**MODIFICATION TO DA2018/1332 - 207 & 199 FOREST WAY, BELROSE
PLANNING PANEL REF: PPSSNH-159**

This letter has been prepared on behalf of Lendlease - Retirement Living (the Applicant) to provide Sydney North Planning Panel (Planning Panel) with an overview of the modification (MOD2020/0431) proposed to the approved Development Application (DA), being DA2018/1332, at 207 and 199 Forest Way, Belrose (the site) and provides a response to the key issues raised in Council's Assessment Report to be considered by Planning Panel at its meeting on 27 January 2021.

Figure 1 Glenaeon – Existing Conditions

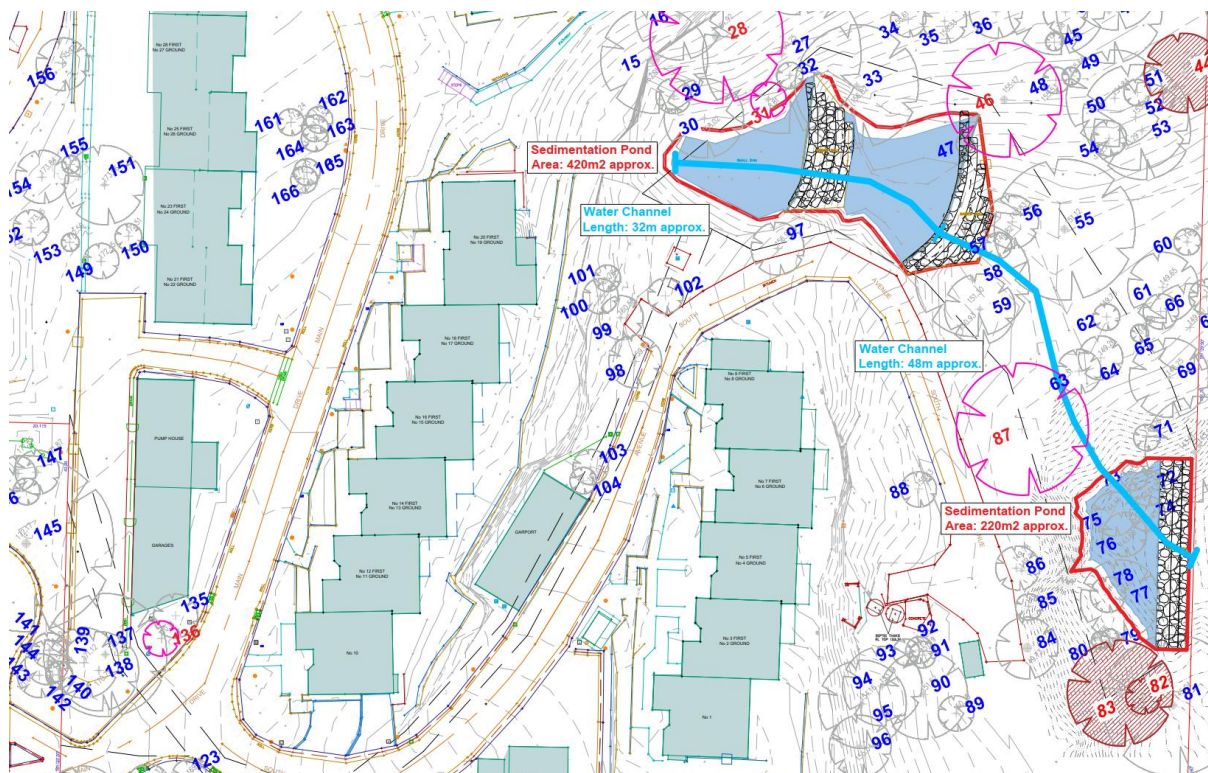
Figure 1: Existing Conditions. Shows the two upper (420m²) and one lower (220m²), existing, 30-year-old sedimentation ponds connected by 48m of natural flow path through undeveloped bushland.

Figure 2 Glenaeon – proposed modification application (reinstatement of Building D)

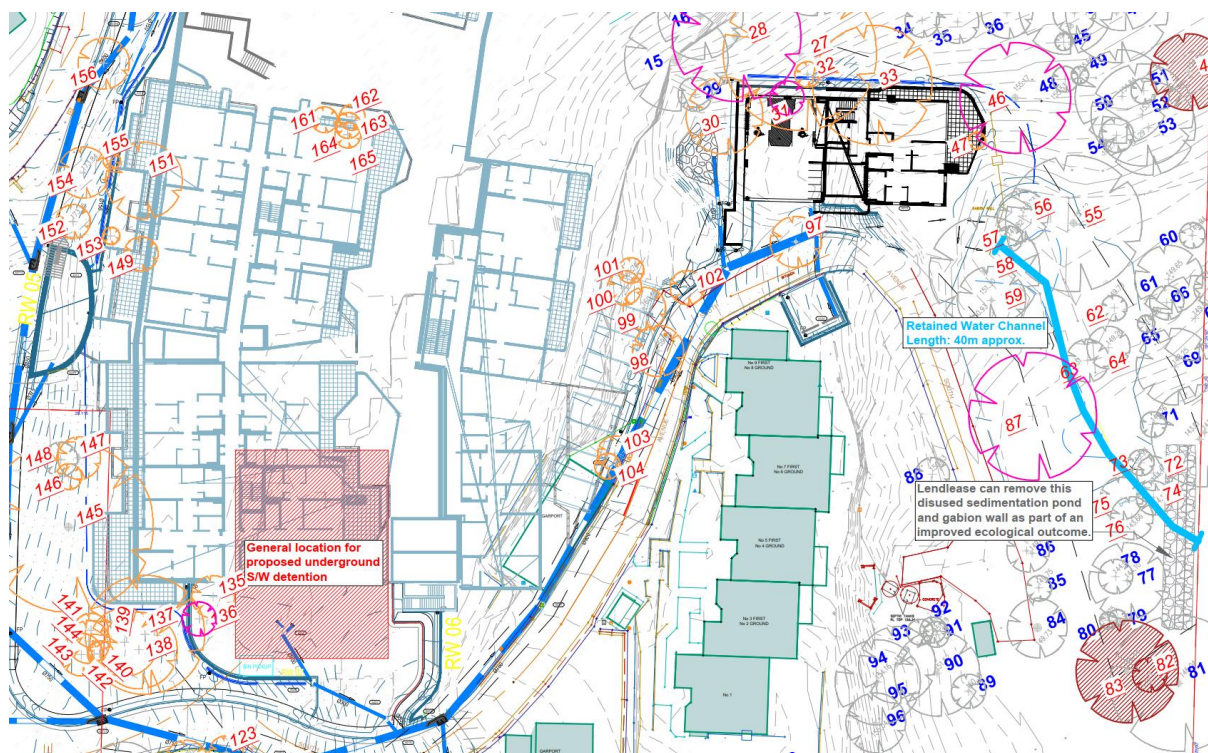
Figure 2: Proposed Modification. Shows the reinstatement of Building D (540m²) largely over the existing, 30-year-old upper two sedimentation ponds (420m²) as well as the relocated stormwater system (in red) under the main development's garage forecourt. It also demonstrates the retention and enhancement of the undeveloped bush at the site boundary along with the retention and enhancement of 40m of the existing flow path.

It is noted that the Applicant is happy for the lower existing detention pond (220m²) to be removed via condition of consent as it will not serve a purpose should the modification be approved. With the removal of this pond the total developed area would be reduced to 540m², which is 100m² less than the existing predevelopment situation and 620m² less than the approved scheme.

Figure 3 Glenaeon – approved DA 2018/1332

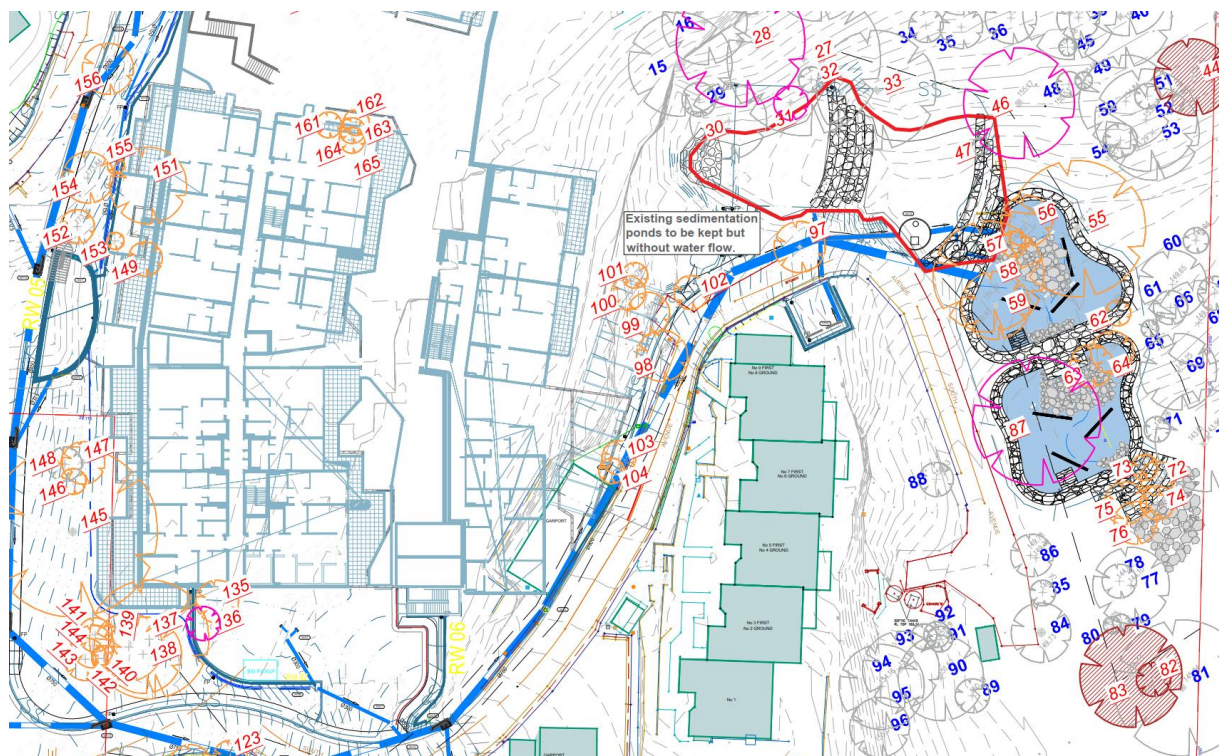
Figure 3: Approved DA. Shows the retention of the two existing upper sedimentation ponds (420m² in area) and the lower sedimentation pond removed to make way for two new stormwater detention ponds (740m² in area).

Figure 3. Slope of the upper part of the catchment of Snake Creek.

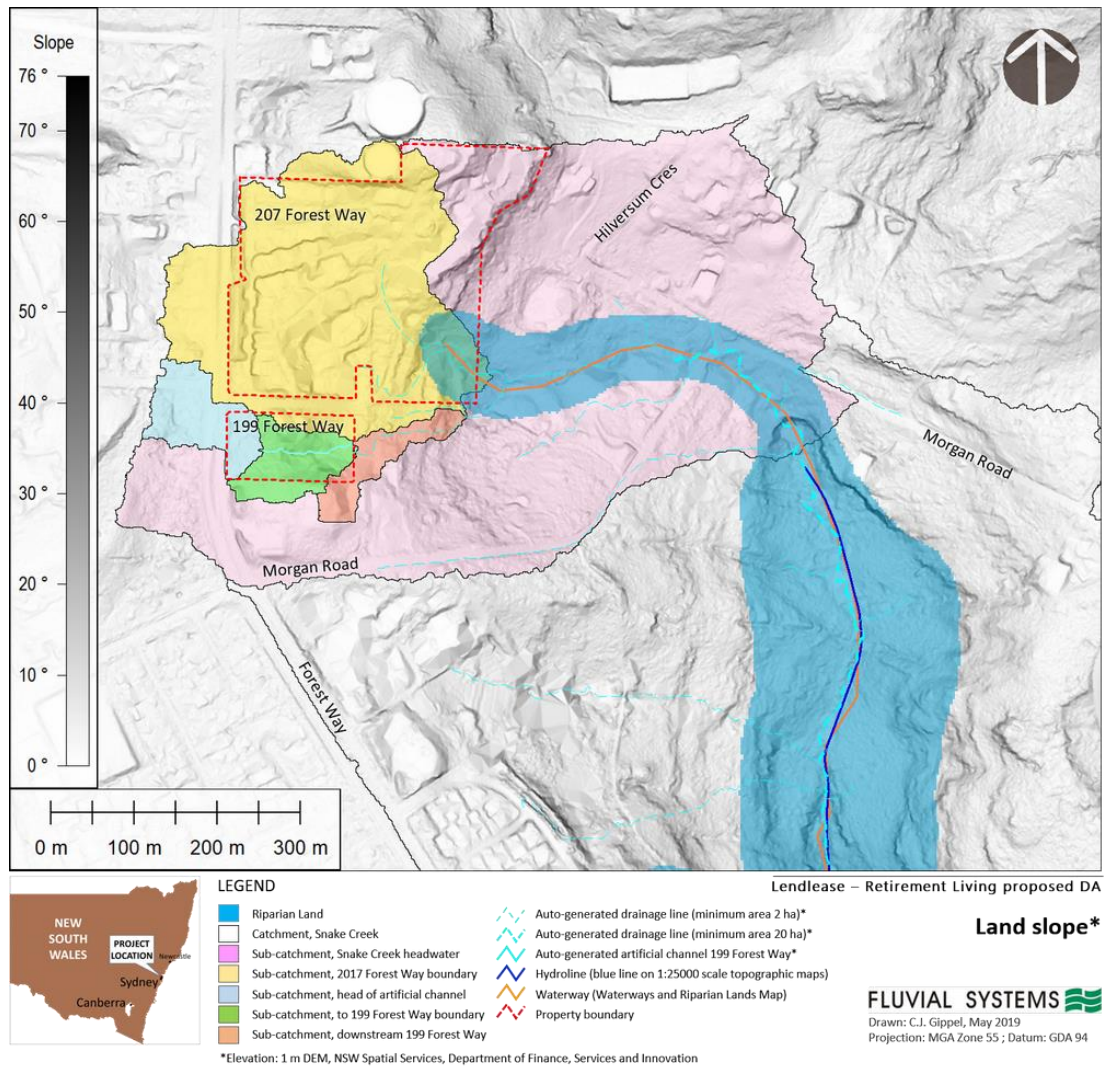
Drainage lines and sub-catchments for Oxford Creek catchment, including Snake Creek sub-catchment, were automatically generated using the ‘Generate Watershed’ algorithm in Global Mapper GIS (Geographic Information System), with the minimum sub-catchment area set to 20 ha. This produced drainage lines that were less extensive than the 1:25,000 blue lines (hydrolines) (Figure 1), indicating that some of the catchments draining to the top of blue lines are less than 20 ha in area. This was not the case for upper Snake Creek, where the blue line was shorter than the auto-generated drainage line (Figure 2). The catchment draining to the top of the blue line was 35.60 ha. In preparing the topographic map, the cartographers decided to begin Snake Creek blue line at the base of a 10 m high, near vertical (slope up to 70 degrees) rock knickpoint (Figure 3).

Figure 4. Detail of drainage of land around 207 Forest Way, Belrose.

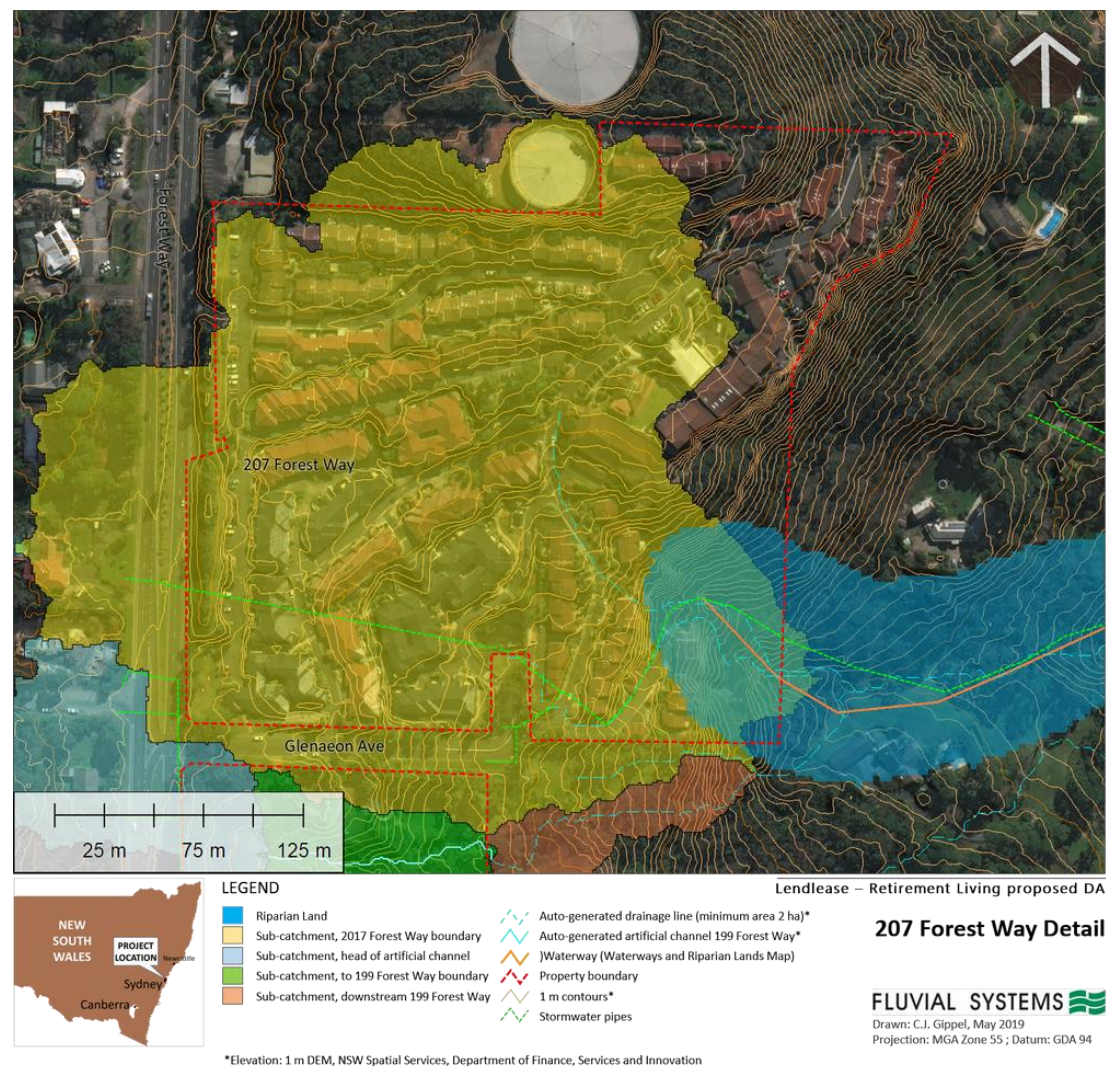
The Riparian Assessment by Cardno (2018) argued that the Map of Waterways and Riparian Lands (MWH, 2004) erred in extending the Snake Creek headwater tributary drainage line into the land covered by 207 Forest Way, Belrose (Figure 4).

Cardno (2018) accurately described the area in question as heavily modified by urbanisation and stormwater management. This includes Council-owned stormwater drainage (Figure 4) that empties to a series of three existing sedimentation basins that lie within the area of the proposed development. Downstream of the sediment basins, on the adjoining property, a dam was constructed some time between October 2012 and April 2013. The Council Waterways line projects through these structures to approximately the base of a sandstone escarpment (Figure 3, Figure 4). For a distance of about 70 m downstream of the dam, the land over which the Council Waterways line is drawn is grassed, and no channel is evident.

Figure 5. Parish Map of area covering location of proposed development.

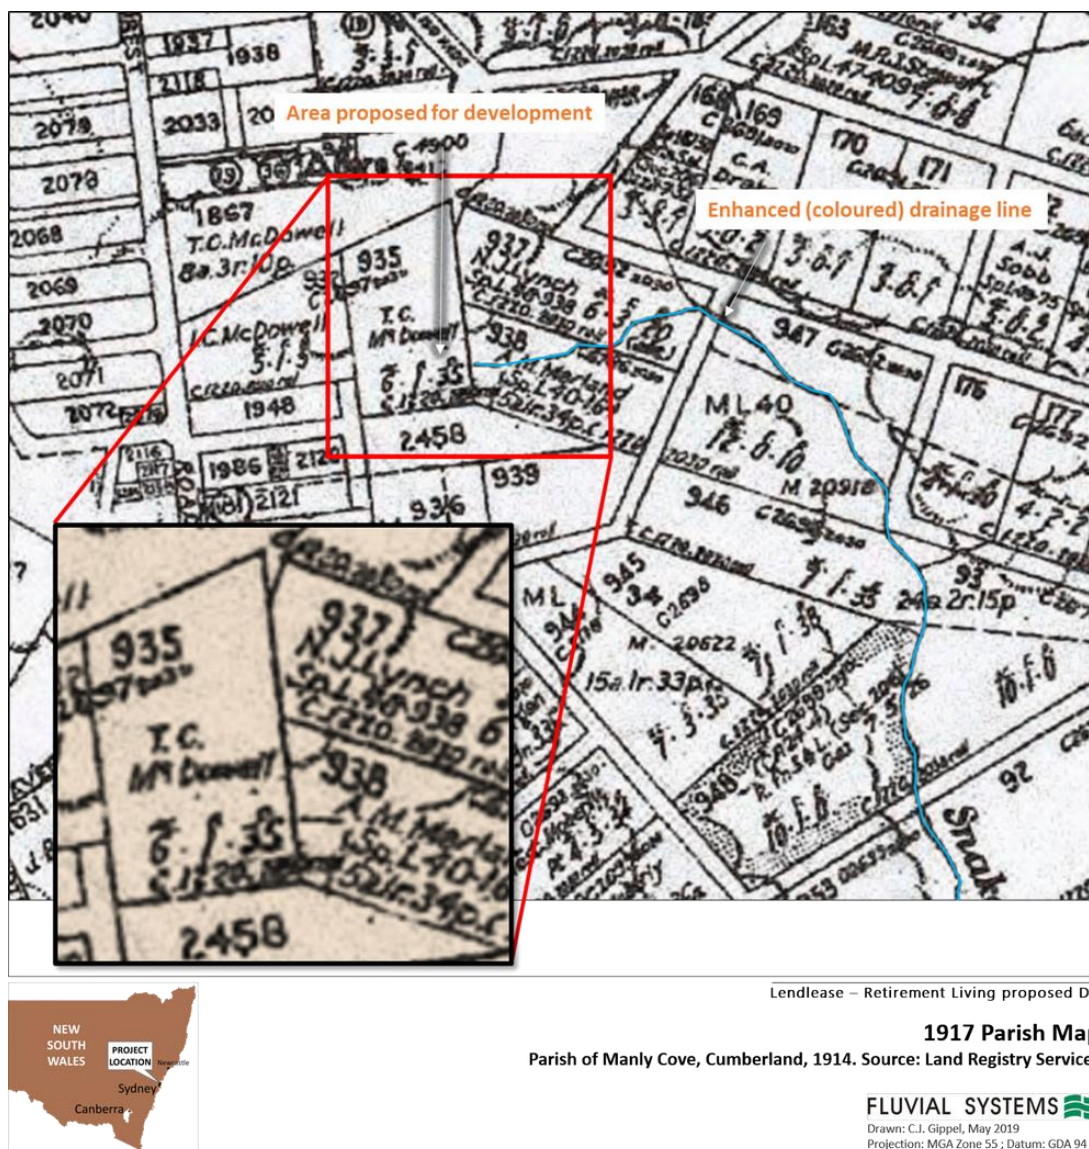
From the perspective of WLEP 2000, EP&A Act 1979 and WM Act 2000 definitions, the issue mainly hinges on whether the section of drainage line in question is an artificial waterbody, or an artificially modified natural waterbody. Topographically, the area naturally was, and is, a runoff flow path, but nearly all land in catchments drains water downhill under storm event conditions, so a runoff path alone does not make a watercourse. According to most legal definitions of watercourse, the flow must be confined, and a channel and other characteristic properties would be present. When the 1:25,000 maps were drawn, the cartographers decided the drainage path did not possess sufficient characteristics of a watercourse to be marked as a blue line. For this reason the flow path would not normally meet the WM Act 2000 definition of a watercourse. An earlier 1917 Parish Map did draw the drainage line extending further upstream than the 1:25,000 blue line, but it stops just short of the boundary of 207 Forest Way (Figure 5).
